ERL and System Performance for 50GBASE-CR

Presented at May 2018 Pittsburgh interim.

- This presentation is related to comment r02-15, and also investigates the effect on system performance as measured by COM of changes in ERL parameters and specifications. It builds on work presented in dudek_3cd_01_0318.

COM vs. Adjusted Host ERL

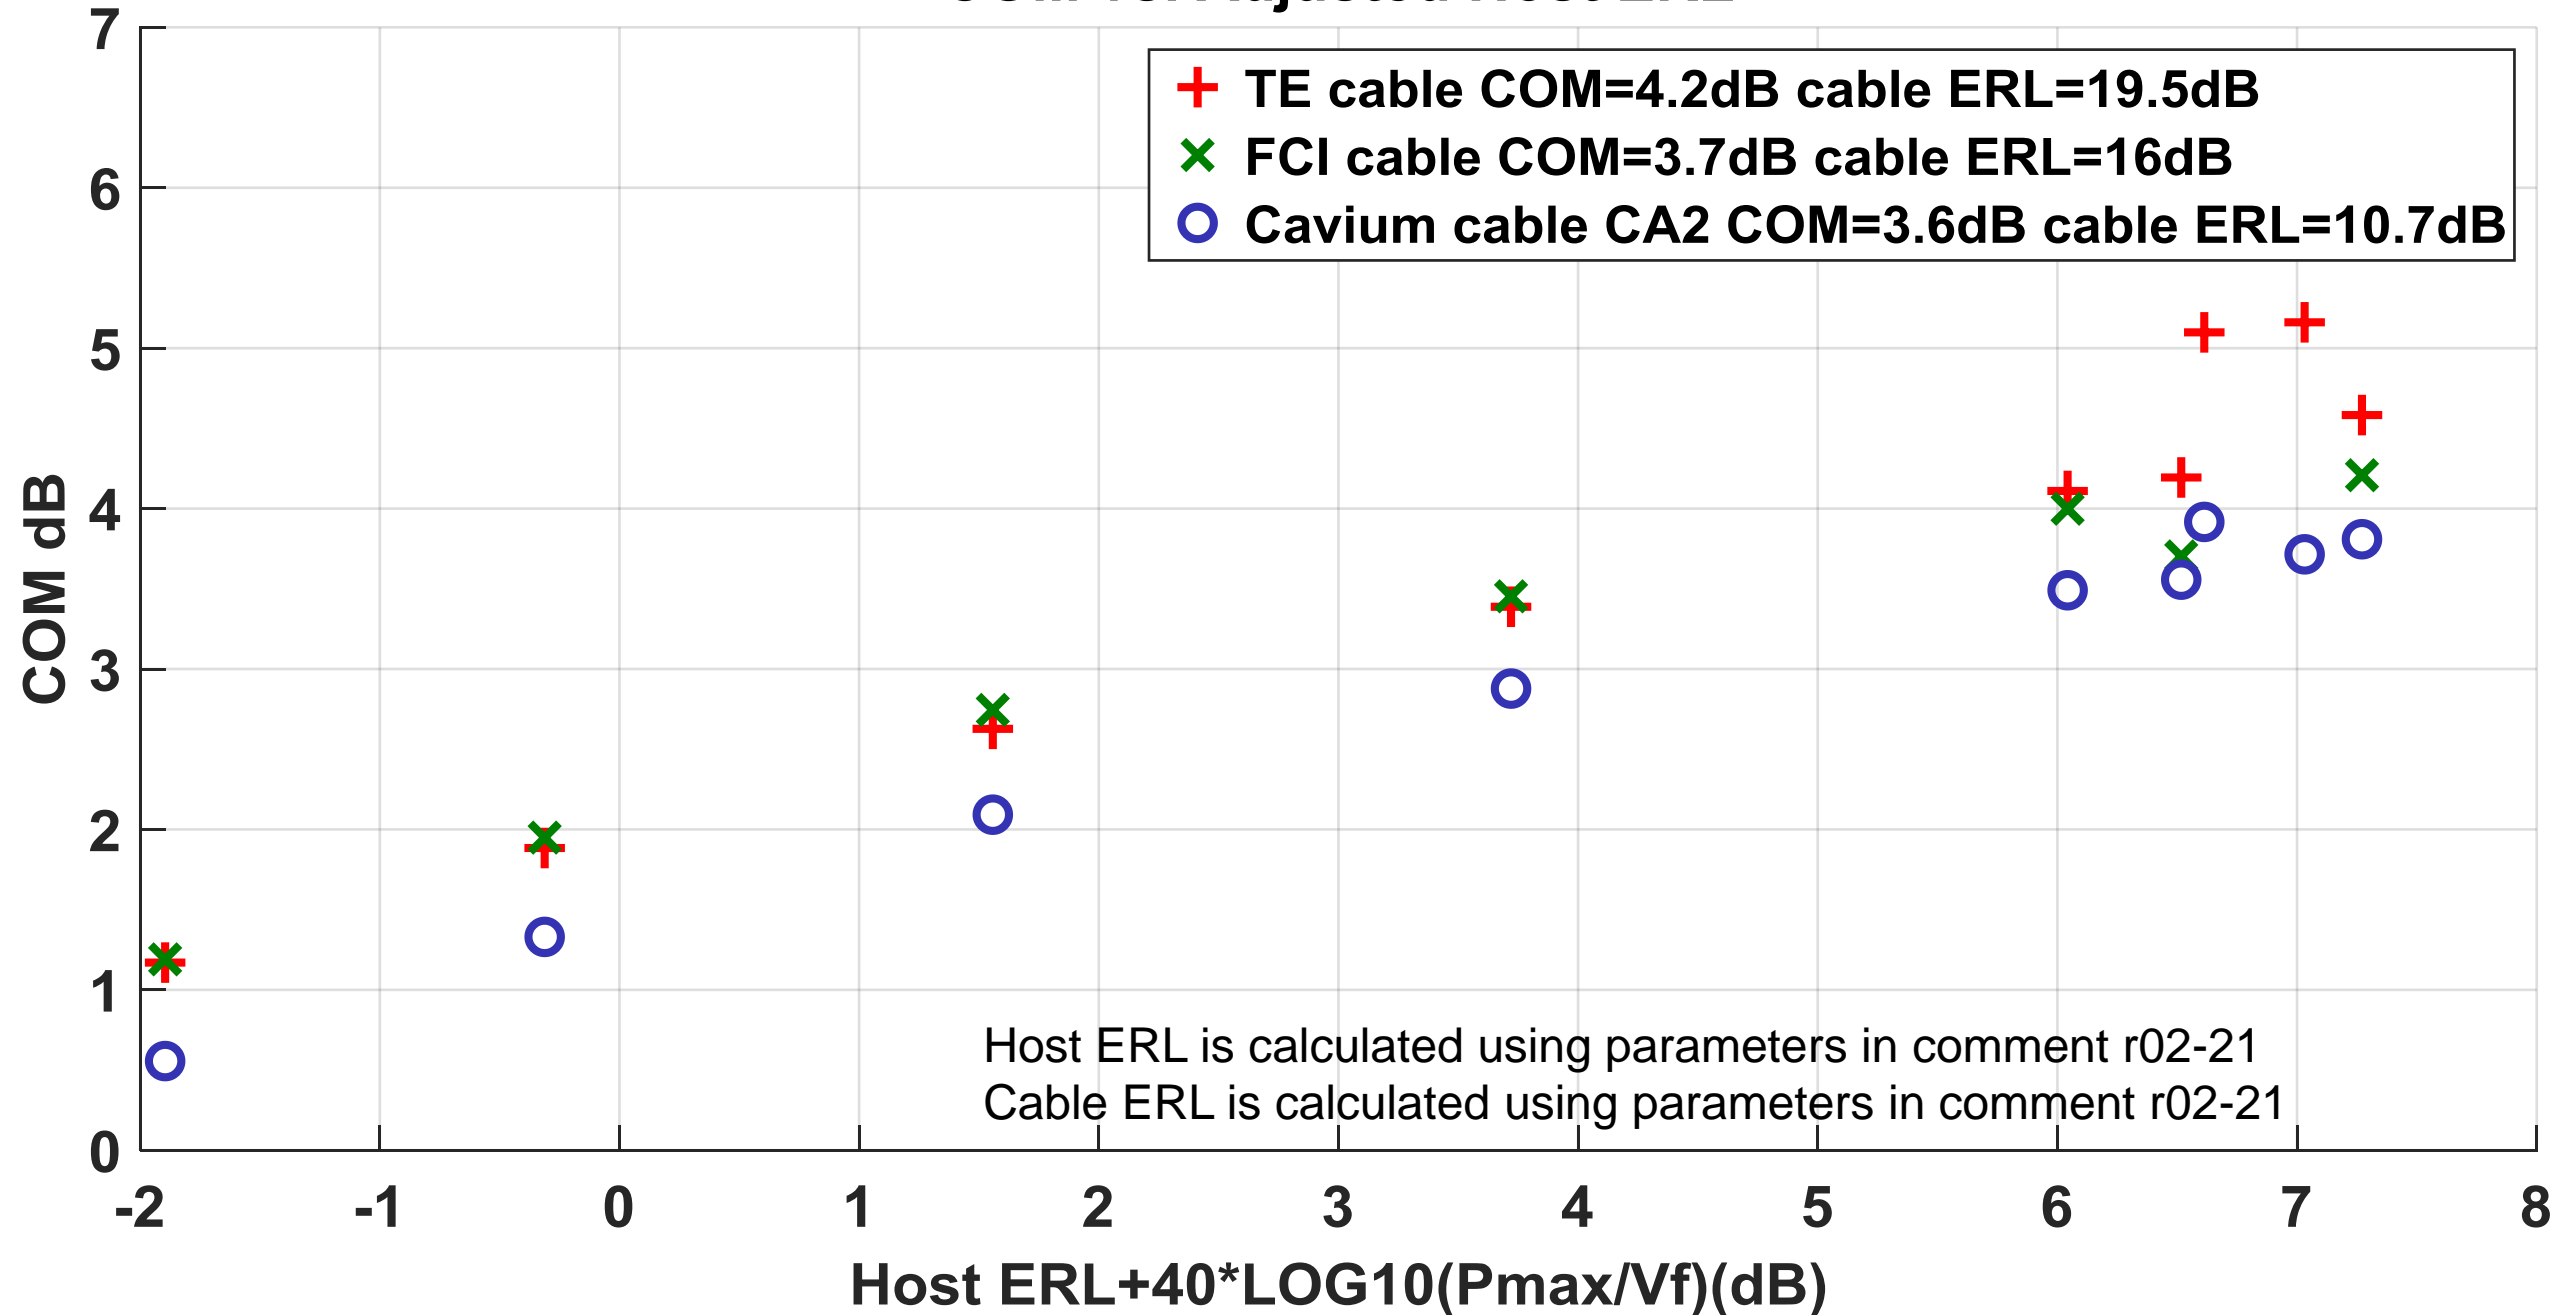
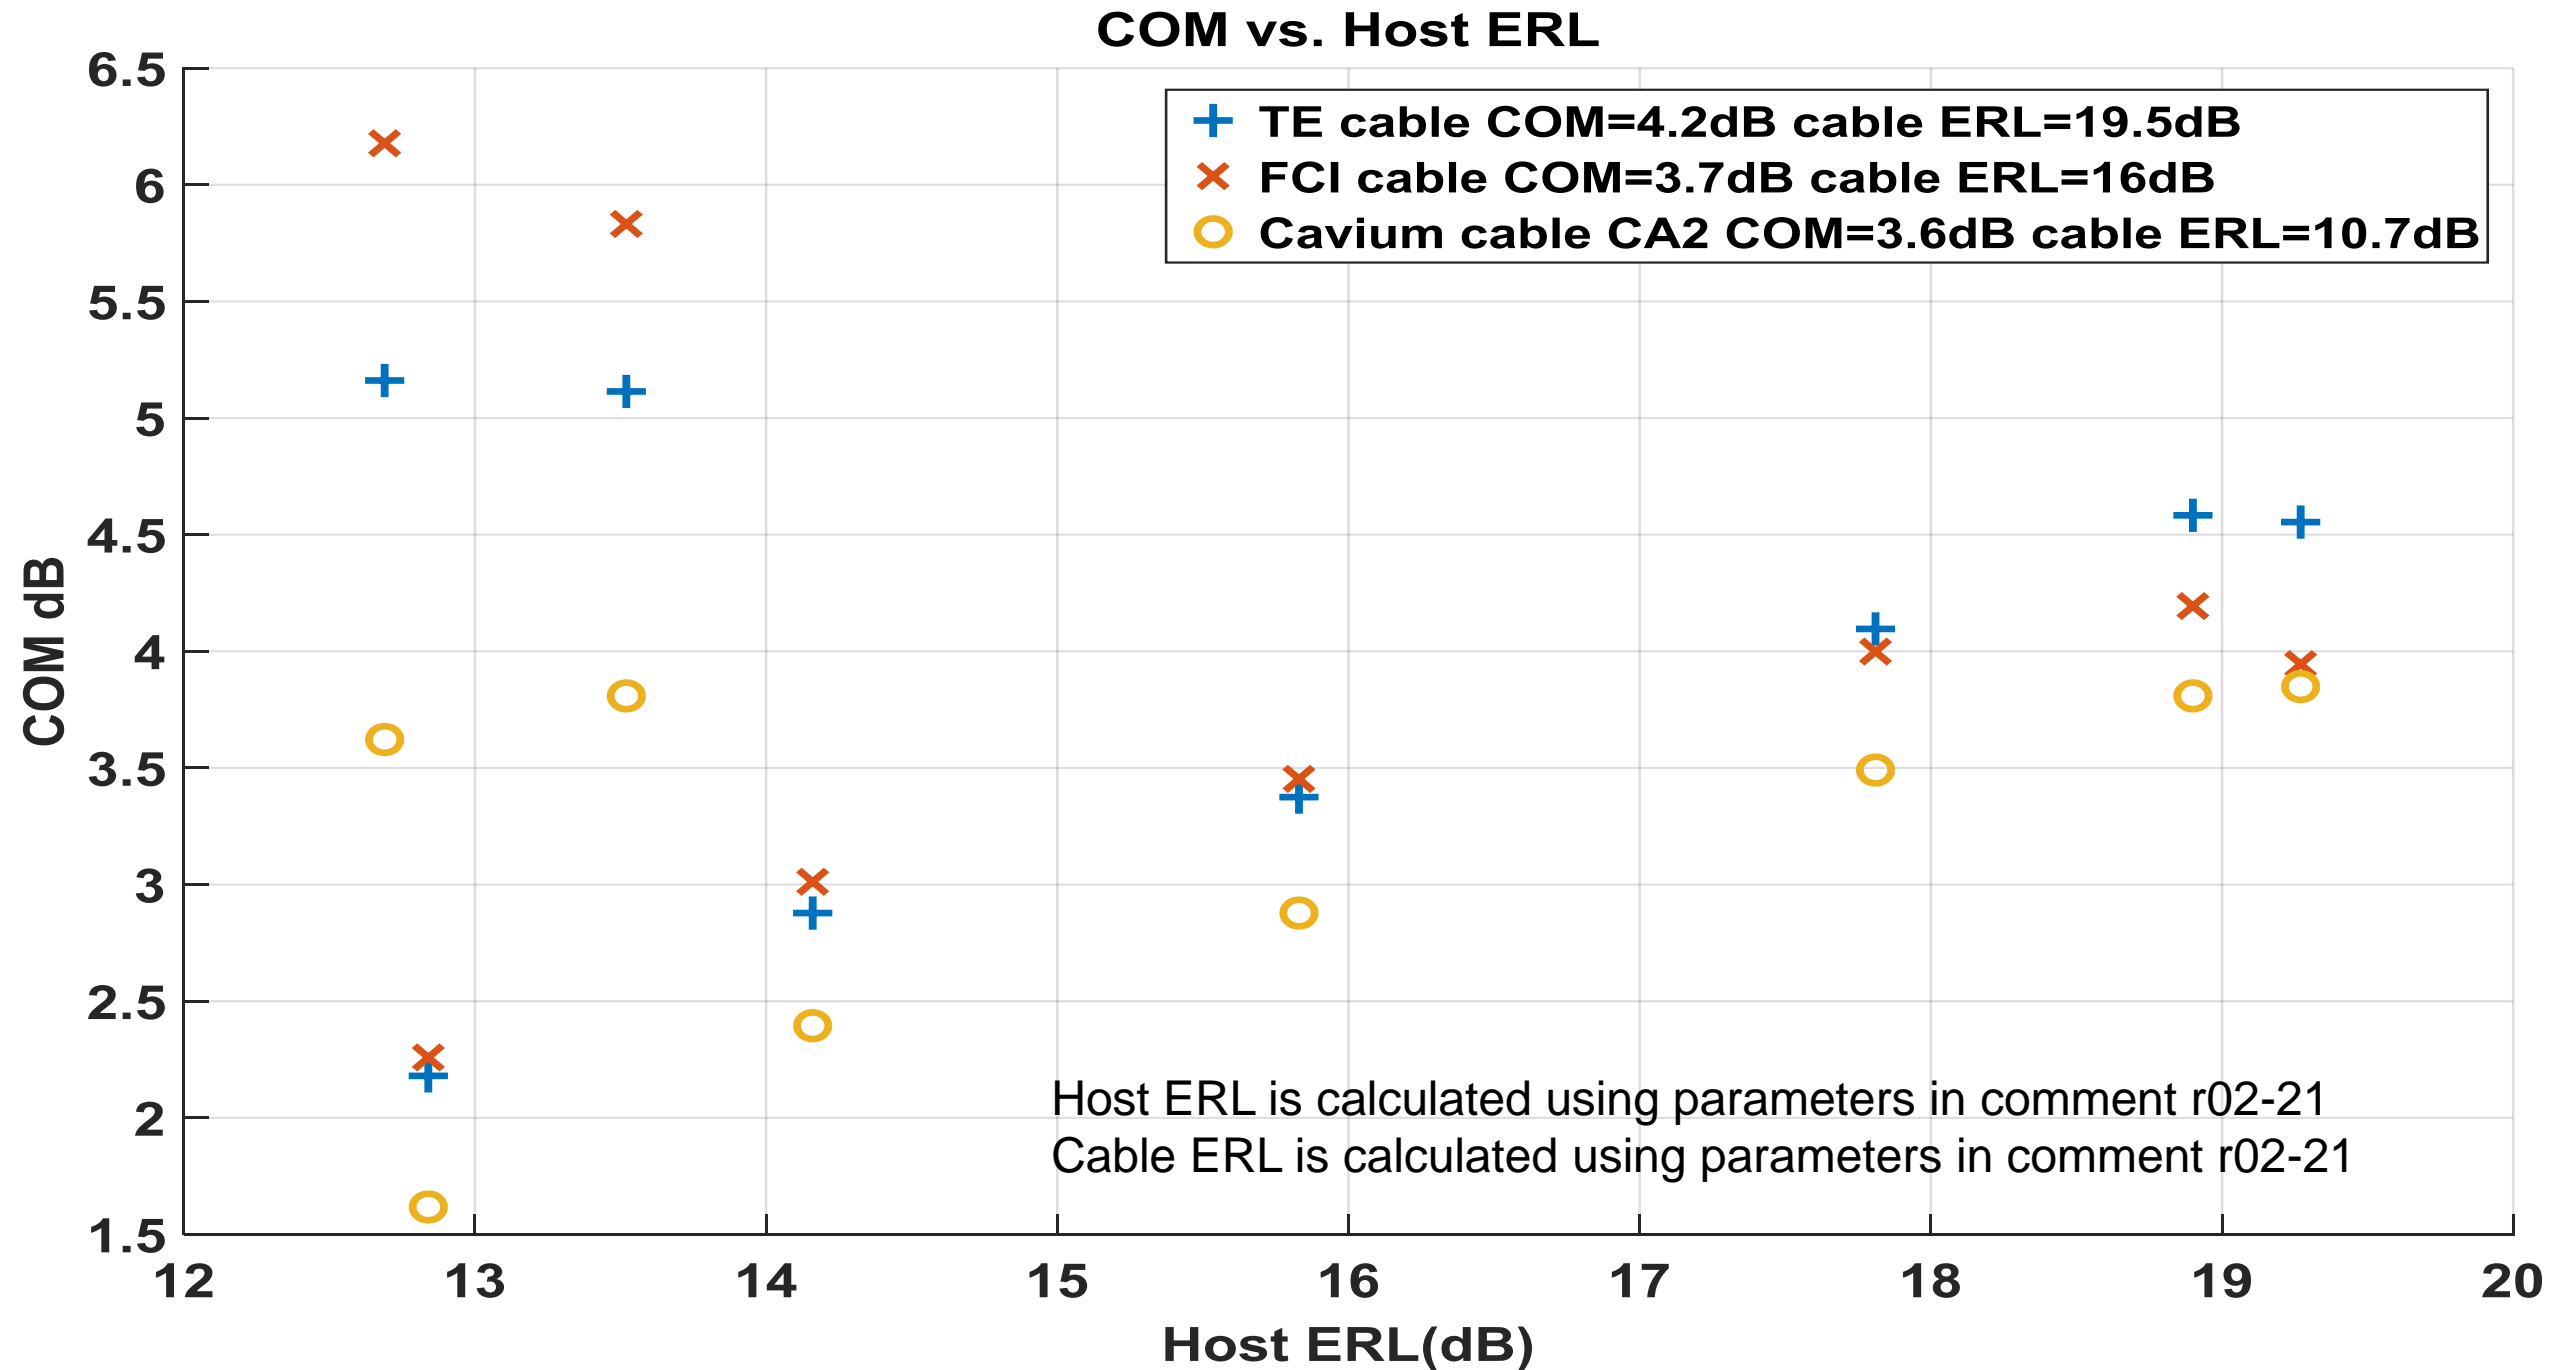
- **The proposed changes to the ERL parameters result in different ERL values (approximately 3dB lower). There are technical justifications for the changes and we recommend they are accepted but the ERL pass/fail limit needs to be adjusted.**
- **The short hosts provide good system performance on these cables and are a likely implementation. They should pass the Tx specification.**
- **The long host with the Cb capacitance at 0.3pF provides bad system performance on all these cables (and particularly CaviumCA2). It should fail the Tx specification.**
- **It has been proposed that the specification should be a single value of ERL, a single value of SNR_{Risi} or a combination of a single value of ERL plus a single value of SNR_{Risi} however no single values for these parameters exists that will not have false passes or false fails with these hosts.**

- **The new ERL parameters should be adopted.**
- **A specification of $ERL \geq 4dB - 40 * \text{Log}_{10}(P_{max}/V_f)$ should then be adopted.**
- **Note that it has been suggested that it is inconvenient having this combined specification as ERL is generally measured with a VNA and post processing and P_{max}/V_f is measured with an oscilloscope and post processing. With this specification however test engineering could choose to use fixed pass/fail values for the testing of their product depending on the product type with a choice of paired values. E.g.**
 - $P_{max}/V_f \geq 0.49$ $ERL \geq 16.4$
 - $P_{max}/V_f \geq 0.55$ $ERL \geq 14.4$
 - $P_{max}/V_f \geq 0.63$ $ERL \geq 12.0$
